In the matter of the application by Douglas T. Harrison for TPDES No. WQ0016211001 TCEQ Docket No. 2024 – 1723 – MWD

Kira Olson's reply to responses by ED, Doug Harrison, OPIC

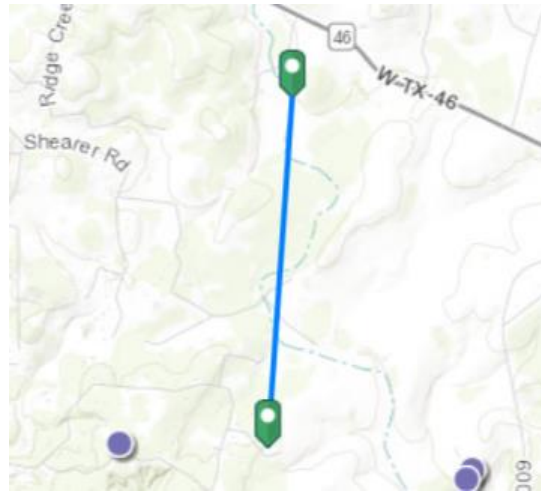
- The Harrison wastewater treatment facility is sited in the contributing zone, its discharge point is located just 2,000 feet upstream from the recharge zone boundary. Discharging effluent into a dry creek so close to the recharge zone means that the effluent will reach the recharge zone undiluted much of the time. During periods of flooding that are characteristic of the Texas Hill

Country, contaminated water will flow for over 10 miles across the recharge zone. Our well is located approximately within 2 miles of the facility as shown below.
